Informal document **GRE-76-21**
(76th GRE, 25-28 October 2016,
agenda item 7(f))

C L E P A
*European Association of
Automotive Suppliers*

Analysis of the Polish proposal. GRE2016/18

Assessment of the width of the beam pattern:
Measurement points for Xenon HL (R98)

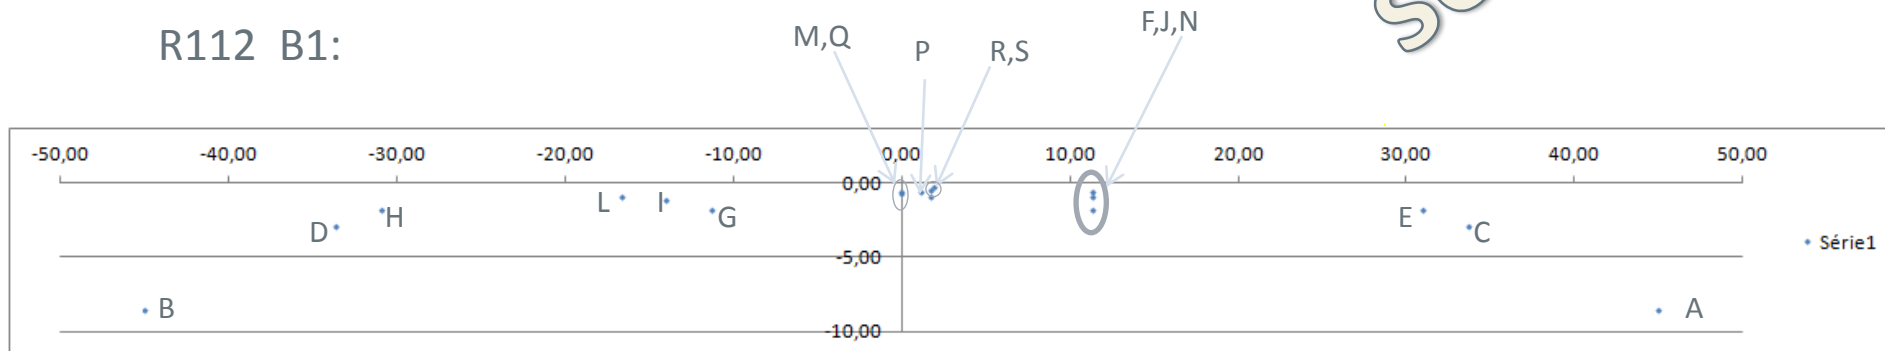
Same
scale!

R112 B1:

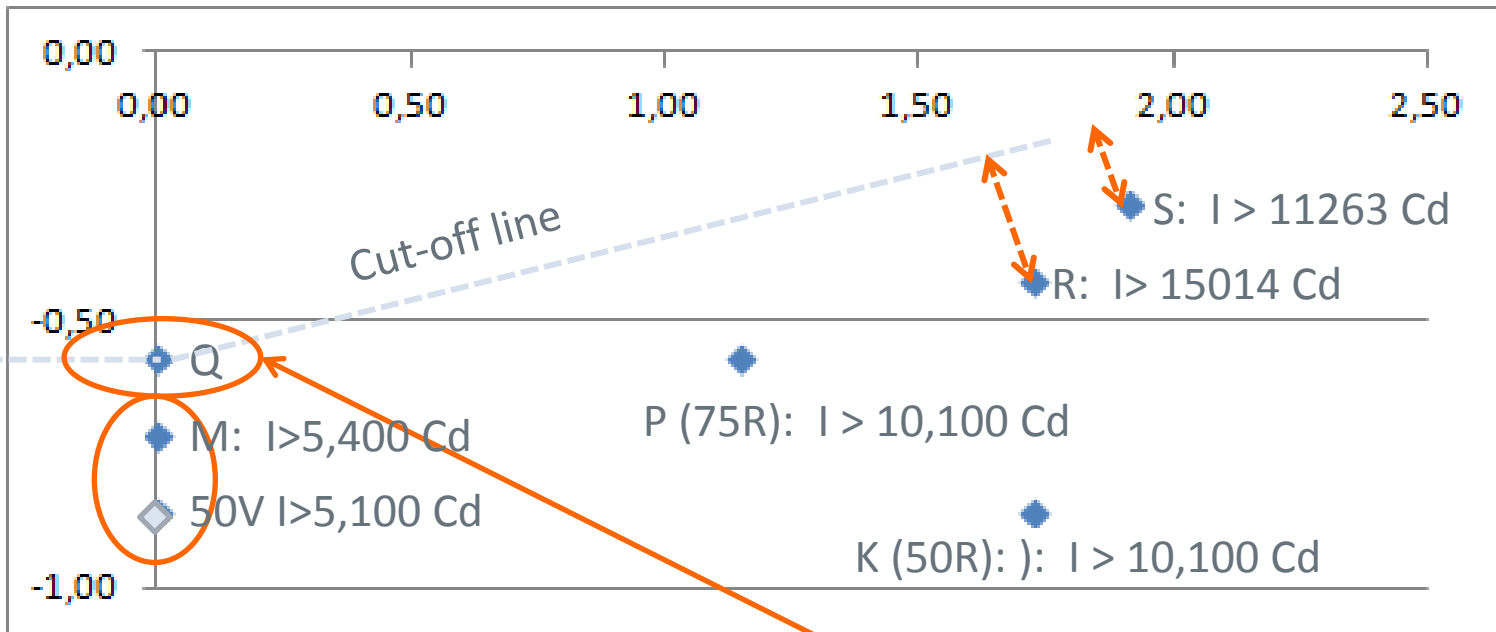
Comments:

- A, B, C, D, E, H : Too wide.
- Relevance of 3 points F, J, and N which are very close each other.
- G and F very close to 25L and 25R respectively: to be removed.

Zoom on the hot spot area

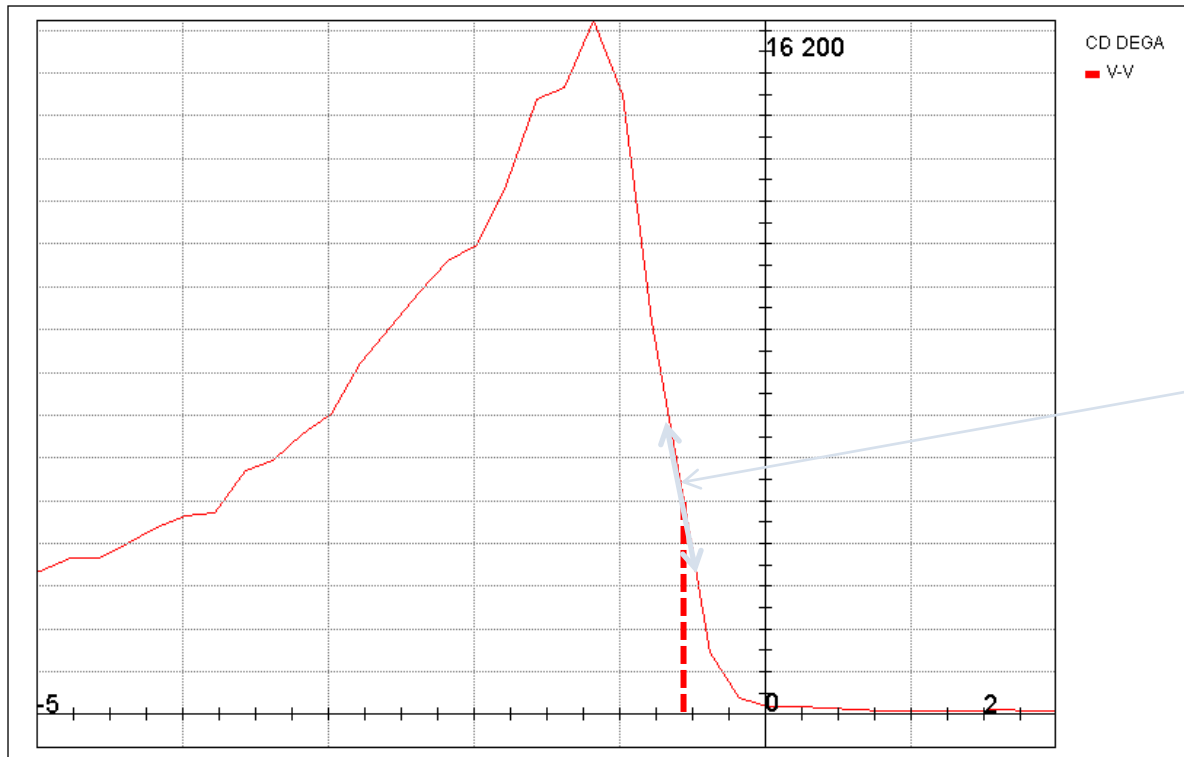
« Q » on the Kink point

Comments:

- **Q** is exactly on the kink point of the cut-off:
 - Repeatable measurements are impossible.
- **M** is very close to V50 in R112 ($d = 0.14^\circ$). Redundancy .
- **R & S** are very close each other, close to the cut-off line.
The requirement seems to be difficult to achieve.
Assessment of current HL to be done before a conclusion on these points.
